BALL SUBDIVISION

APPLICATION NUMBER 4 DATE March 1, 2018

REQUEST Subdivision

DETAIL SITE PLAN

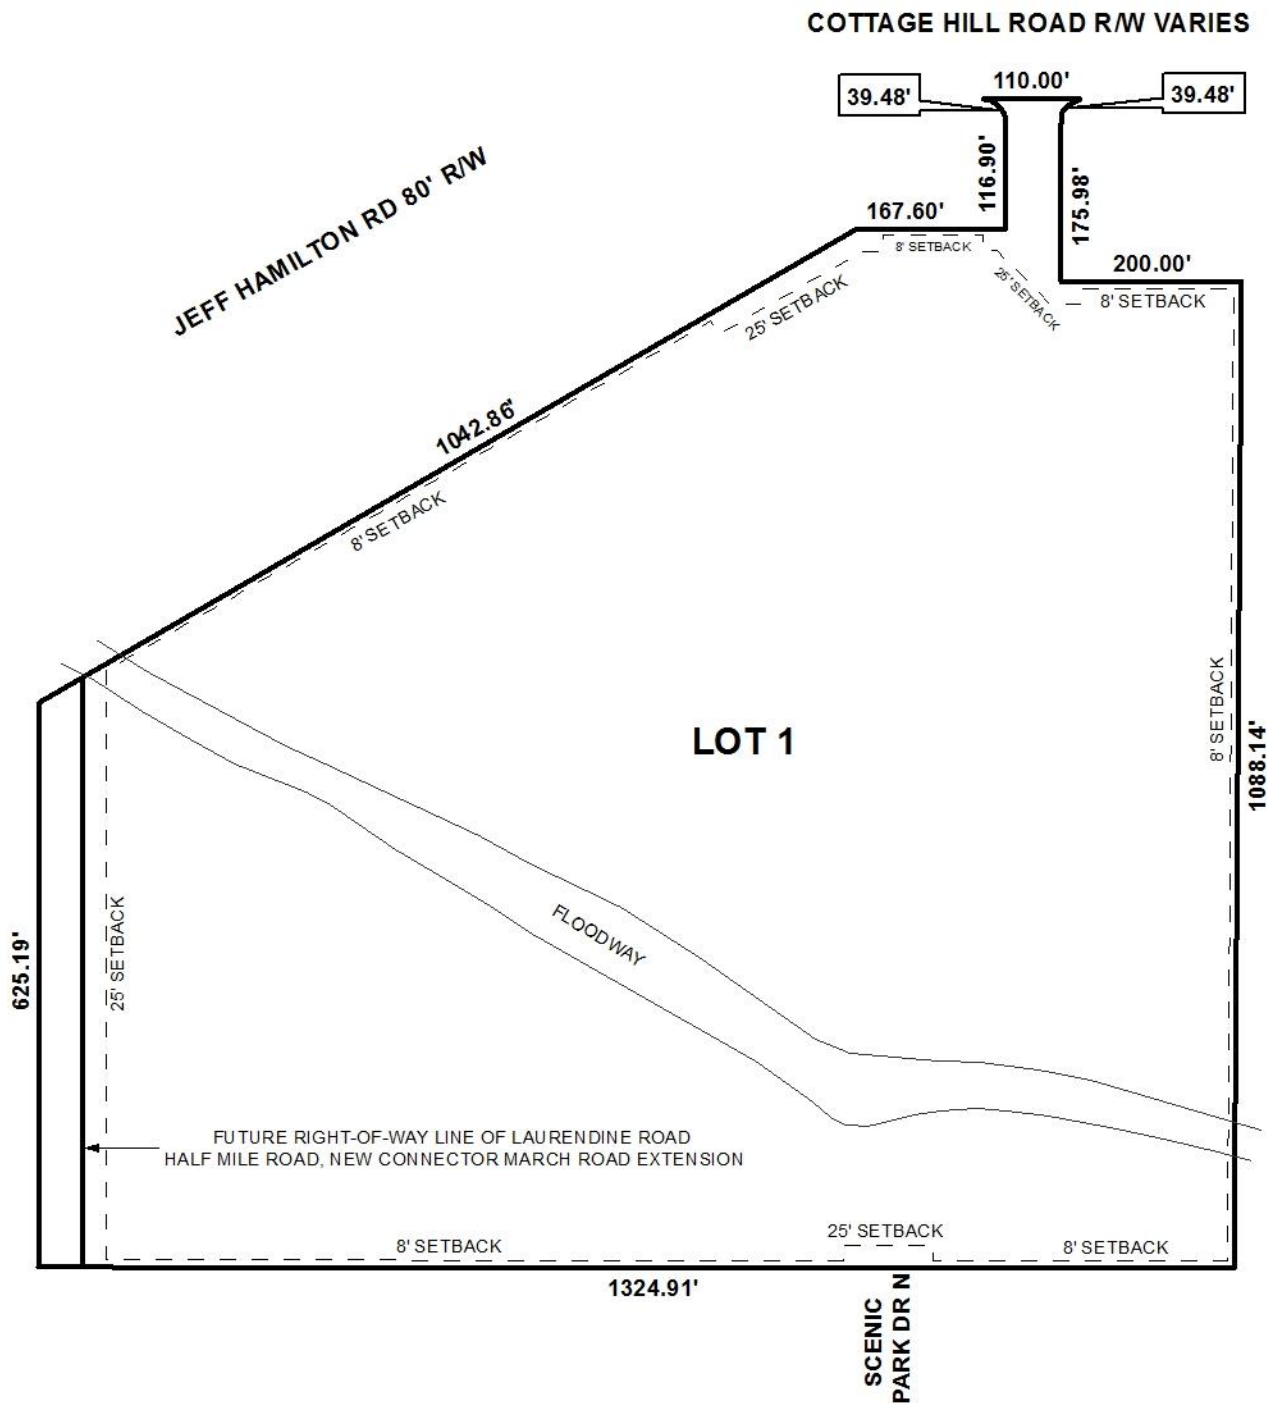
The 25' minimum building setback lines are depicted along all street frontages. The plat should be revised to add the label of "25'" to the minimum building setback label along Laurendine Road-Half Mile Road-New Connection-March Road Extension.

As a means of access management, a note should be placed on the Final Plat limiting the site to one curb-cut to Cottage Hill Road and two curb-cuts to the proposed major street, when it has been built to Mobile County Engineering standards, with the size, location, and design of all curb

cuts to be approved by County Engineering and conform to AASHTO standards. Access to Scenic Park Drive North should be denied.

The proposed lot meets the minimum size requirements of the Subdivision Regulations. If approved, the lot size in square feet and acres should be retained on the Final Plat, or a table should be furnished providing the same information.

A note should be placed on the Final Plat stating that if the site is developed commercially and adjoins residentially developed property, a buffer must be provided in compliance with Section V.A.8. of the Subdivision Regulations.

- 1) revision of the plat to depict the minimum right-of-way widths along Cottage Hill Road and Scenic Park Drive North;
- 2) dedication of right-of-way along Cottage Hill Road if necessary to provide 50' from centerline;

- 3) dedication of right-of-way, as depicted for the proposed major street;
- 4) revision of the plat to label the 25' minimum building setback line along Laurendine Road-Half Mile Road-New Connection-March Road Extension ;

- 5) retention of the 25' minimum building setback line along all street frontages;
- 6) placement of a note on the Final Plat stating that the lot is limited to one curb-cut to Cottage Hill Road, and two curb-cuts Laurendine Road-Half Mile Road-New Connection-March Road Extension, with the size location and design to be approved by Mobile County Engineering and conform to AASHTO standards;

- 7) placement of a note on the Final Plat stating access to Scenic Park Drive North is denied;
- 8) retention of the labeling of the lot in size in both square feet and acres, or the furnishing of a table on the Final Plat providing the same information;
